Memorandum to the City of Markham Committee of Adjustment

File: A/022/20
Address: 78 Fred Varley Drive – Markham, ON
Applicant: Decheng Liu & Zhi Yuan Luo
Agent: Gregory Design Group c/o Russ Gregory
Hearing Date: Wednesday March 18, 2020

SITE PLAN

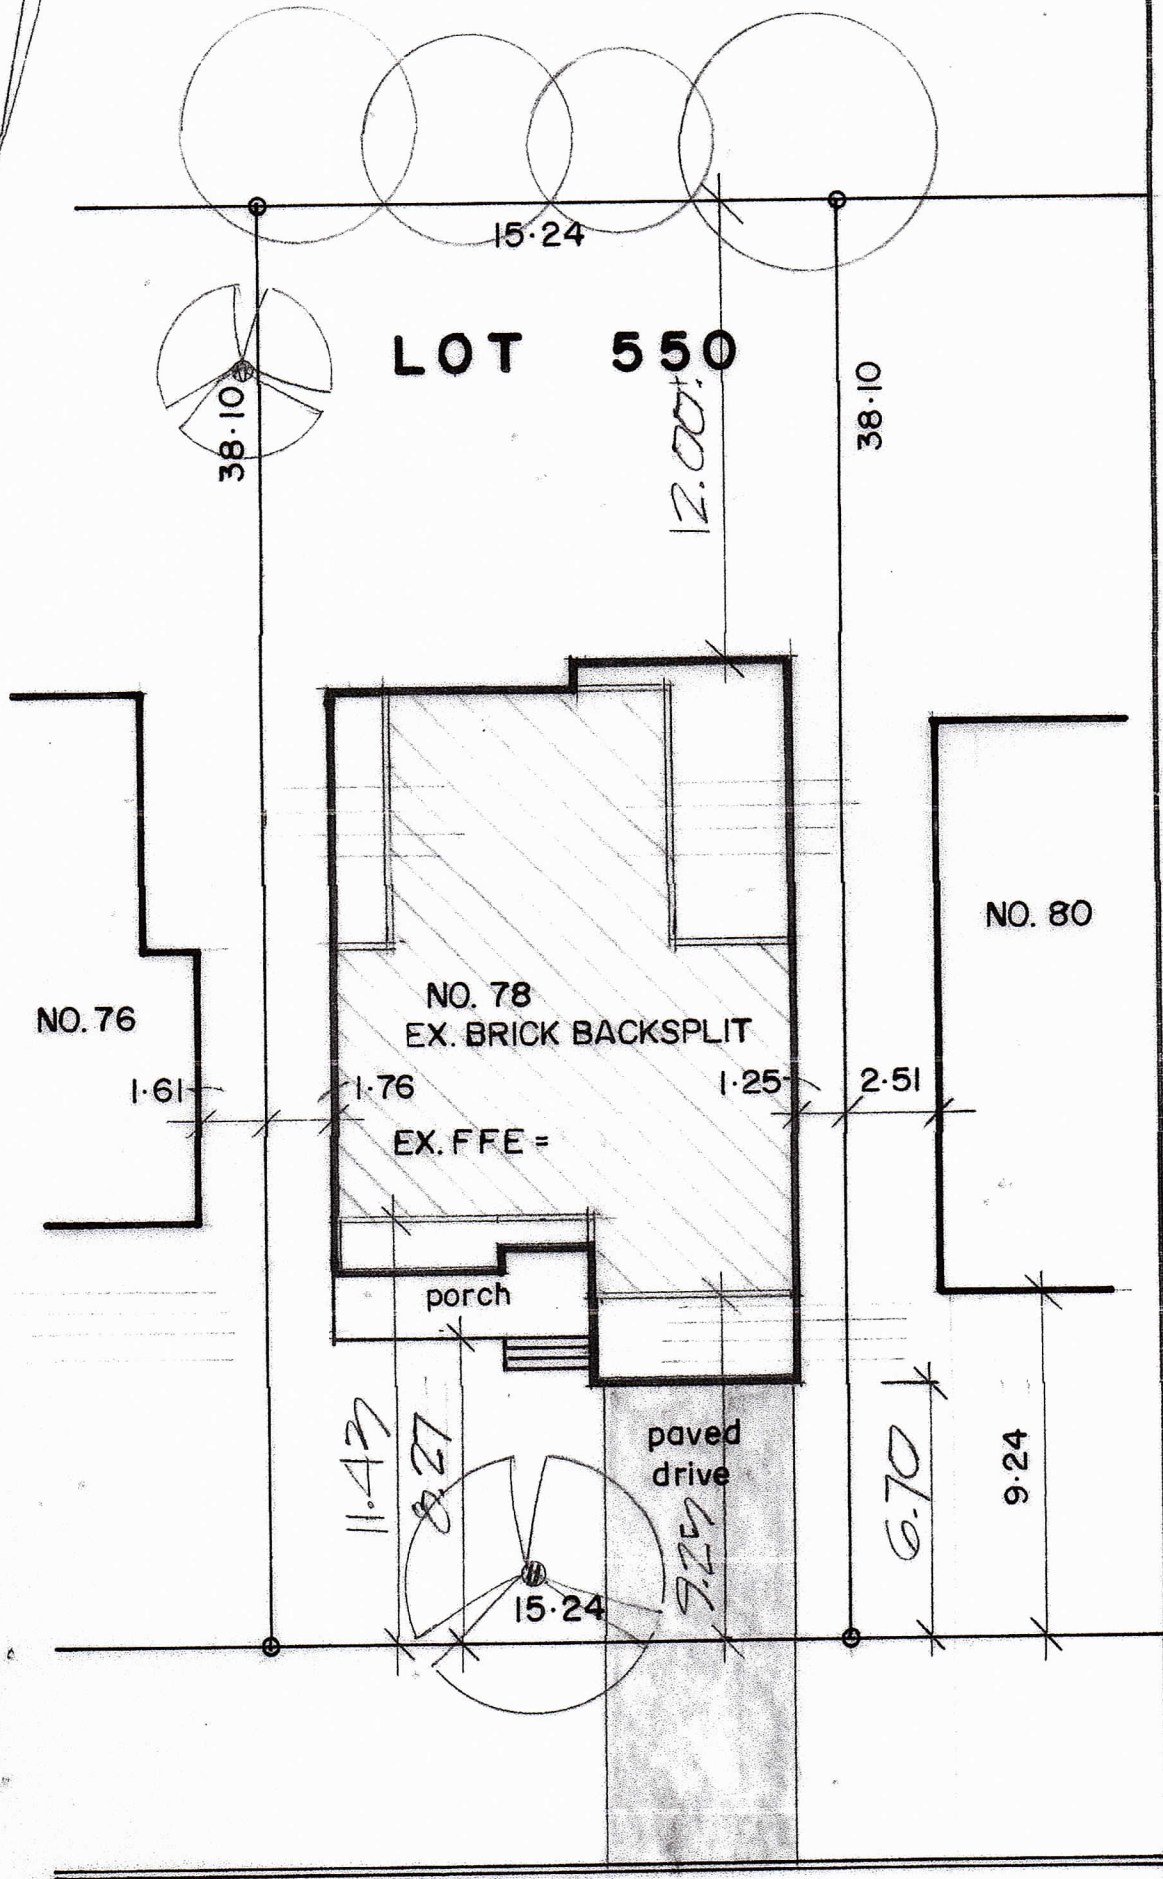
The applicant is requesting a maximum lot coverage of 38.3% (2,394.11 ft²), whereas the By-law permits a maximum lot coverage of 33.3% (2,081.53 ft²). Aside from the request to increase the maximum lot coverage by 5.0% (312.6ft² or 29m²), the proposed development complies with the required setbacks and height restrictions in the R4 zone. Additionally, the second floor has a smaller floorplate than the ground floor, which occupies approximately 27.35% of the lot area. Staff are satisfied that the variance is minor in nature and will not result in a dwelling that is incompatible with its surroundings.

The applicant has provided a revised site plan showing the location of the trees within the limits of the subject property. Of particular note, is one mature tree located in the front yard and neighbouring tree canopies that overhang into the rear yard. The applicant has

confirmed that the tree within the front yard is proposed to be retained. Should Committee approve this application, staff recommend that any approval is subject to the related tree preservation and protection conditions provided in Appendix "A".

1. The variance applies only to the proposed development as long as it remains.
2. That the variance applies only to the subject development, in substantial conformity with the plans attached as Appendix "B" to this Staff Report and received by the City of Markham on February 18, 2020, and that the Secretary-Treasurer receive written confirmation from the Director of Planning and Urban Design or designate that this condition has been fulfilled to his or her satisfaction.

3. Submission of a Tree Assessment and Preservation Plan, prepared by a qualified arborist in accordance with the City's Streetscape Manual (2009), as amended, to be reviewed and approved by the City, and that the Secretary-Treasurer receive written confirmation from Tree Preservation Technician or Director of Operations that this condition has been fulfilled to his/her satisfaction, and that any detailed Siting, Lot Grading and Servicing Plan required as a condition of approval reflects the Tree Assessment and Preservation Plan.

4. That tree replacements be provided and/or tree replacement fees be paid to the City if required in accordance with the Tree Assessment and Preservation Plan, and that the Secretary-Treasurer receive written confirmation that this condition has been fulfilled to the satisfaction of the Tree Preservation Technician or Director of Operations.

5. That prior to the commencement of construction or demolition, tree protection be erected and maintained around all trees on site in accordance with the City's Streetscape Manual, including street trees, in accordance with the City's Streetscape Manual (2009) as amended, and inspected by City Staff to the satisfaction of the Tree Preservation Technician or Director of Operations.
